BLUE BIRD

## INTERMOTIVE GUARDIAN II LIFT INTERLOCK POWER SOURCE

# BULLETIN

**Models Affected:** 2007 - 2010 MICROBIRD Equipped With Feature 31048-07 Guardian II Lift Interlock

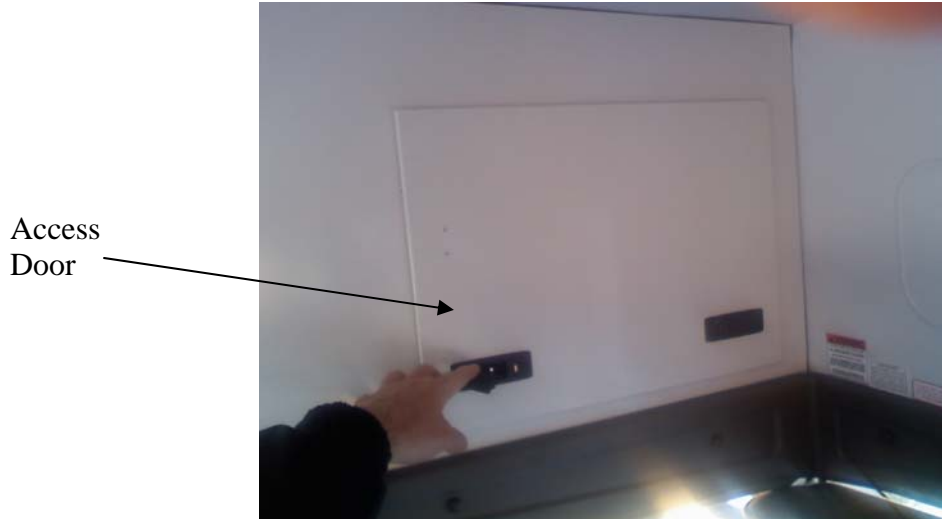
Some buses equipped with the Intermotive Guardian II lift interlock system were incorrectly built with circuit 2502B (Red Wire) connected to ignition power.

2. Unlatch and open access door above the driver seat. (See above photo)

Inspect buses equipped with the Intermotive Guardian II lift interlock system. Buses with circuit 2502B (Red Wire) connected to ignition power will be rewired to battery power.

**Example: 2502B And 10 Amp Breaker Connected to Ignition Powered Position.**

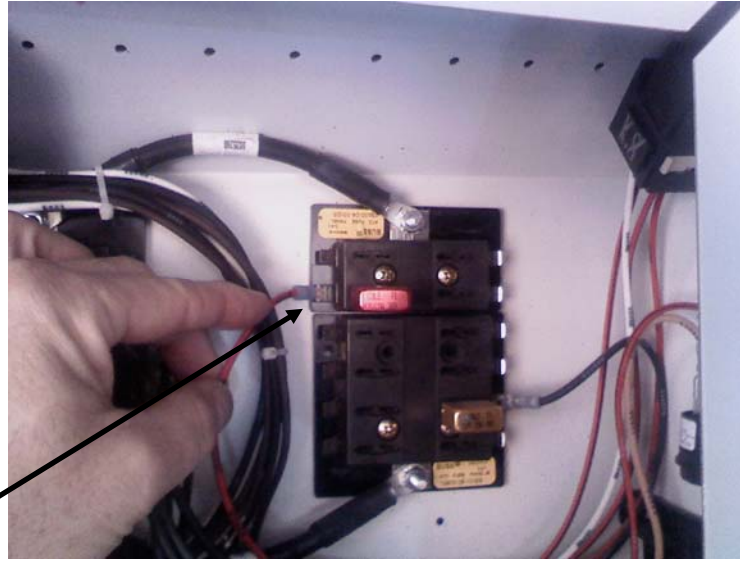
4. Inspect circuit 2502B and determine if it is supplied by ignition or battery power. With ignition key OFF verify voltage on circuit 2502B with a meter or test light.
5. If circuit 2502B is supplied by battery power, no further action required. Replace cover and place bus back in service.

6. If circuit 2502B is supplied by ignition power, relocate circuit 2502B and ten amp circuit breaker to any available fuse panel position that has battery power.
